Heavy Commercial Vehicles

Subject	Side spoiler changes on F-MAX vehicles manufactured before 15.12.2022
Model	F-MAX Vehicles
Summary	During the installation of the new level side spoiler on identified F-MAX vehicles, handle and handle connection bolts must be canceled.

Figure 1: Part to be removed

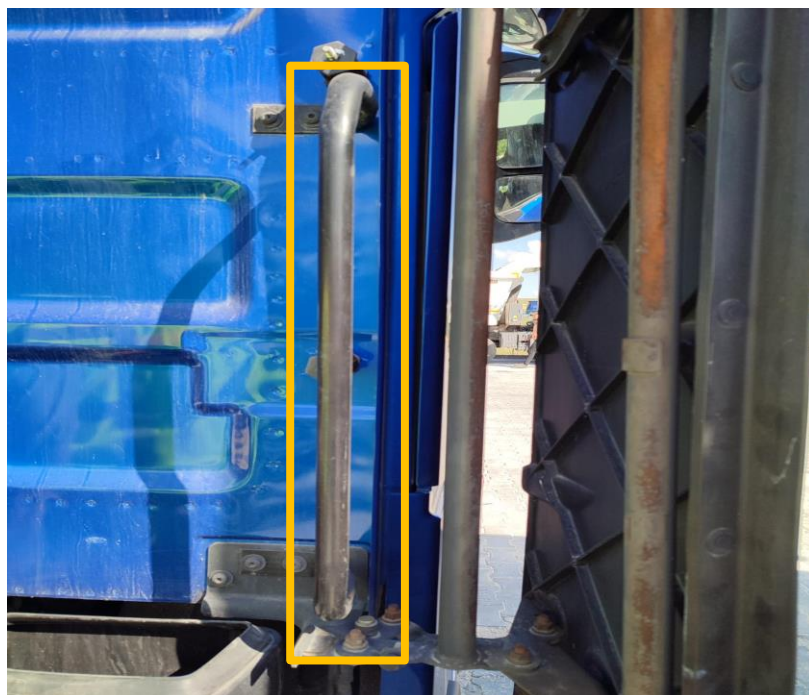
When side spoiler bracket replacement is required in F-MAX vehicles manufactured before 15.12.2022, the handle piece must be removed and the 2 empty bolt holes must be closed with the bolt numbered DC46-V551T14-AA. The handle to be removed is as follows.

Figure 2: Bolts to be removed.

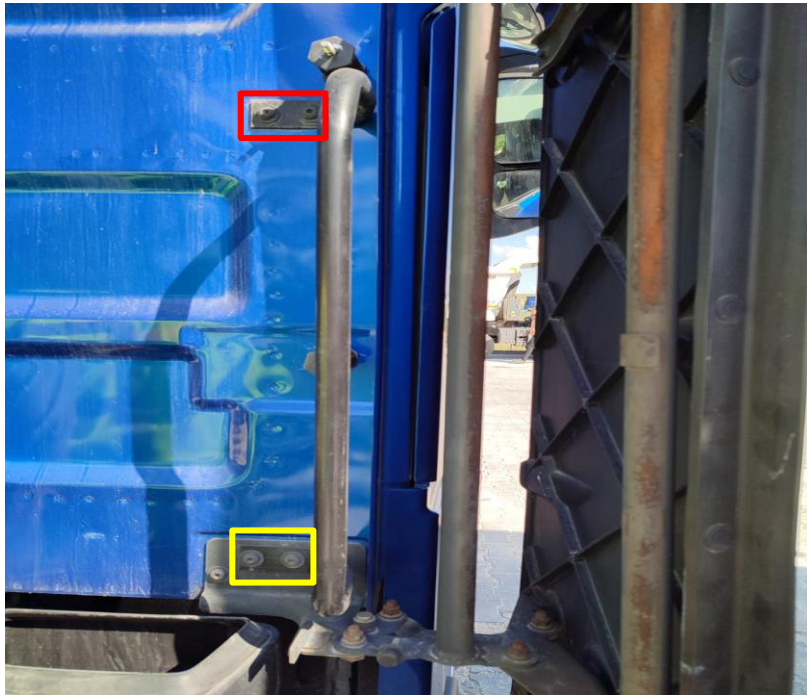
1. As can be seen in “Figure 2” below, after the air duct is removed, the bolt connections in the red and yellow boxes are removed and the handle is separated from the vehicle body.

2. The connection bolts in the yellow box are tightened back into place.
3. Bolts numbered DC46-V551T14-AA are tightened to the connections inside the red box. Completed assembly shown in “Figure 3”.
